**Re: OPV Coalition's Comments on the Draft Oxnard 5-Year GSP Evaluation and the Draft Pleasant Valley 5-Year GSP Evaluation**

**Subject:** **Technical Comments Concerning the Draft *First Periodic Evaluation, Groundwater Sustainability Plan for the Oxnard Subbasin* and the Draft *First Periodic Evaluation Groundwater Sustainability Plan for the Pleasant Valley Basin* (August 2024)**

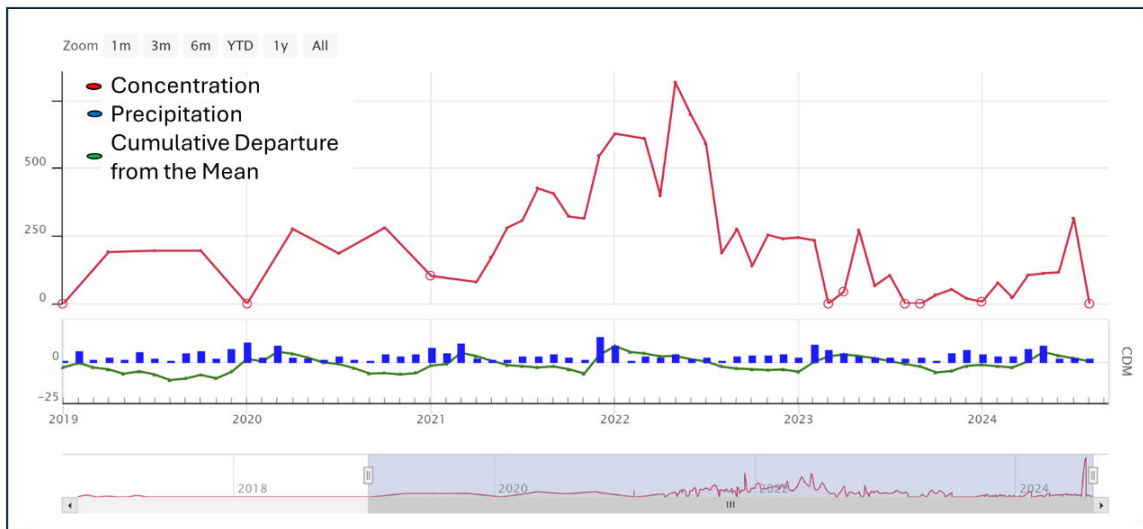
**Recommendation 5:** Monitoring data relied upon in the Evaluations should be made publicly available.

Explanation: In the Evaluations, model outputs and monitoring data are used to interpret progress toward sustainable management and recommend changes to Measurable Objectives and Minimum Thresholds. However, it is unclear what specific role monitoring data played in these decisions, since changes evident in some monitoring data – such as

increases in chloride concentrations – are only available to stakeholders occasionally and in an incomplete fashion via reports and workshops. The Evaluations would facilitate better communication, understanding, and transparency by making monitoring data available in a format enabling stakeholders and the public to access, view, and interpret them. For example, the relationship between water levels and salinity (chloride) and the role of very wet or dry conditions on these relationships can be depicted and evaluated using mixed line-and-bar type charts. Such plots are available, for example, via the HiCharts charting library which enables sharing of data and plots over the web ([www.highcharts.com](http://www.highcharts.com)). An example is provided below: the data in this example plot are unrelated to either the Oxnard Evaluation or the Pleasant Valley Evaluation, but similar plots could easily be made using the data that presumably supported both Evaluations. Once developed, updating of these plots with newly acquired data is a trivial task.
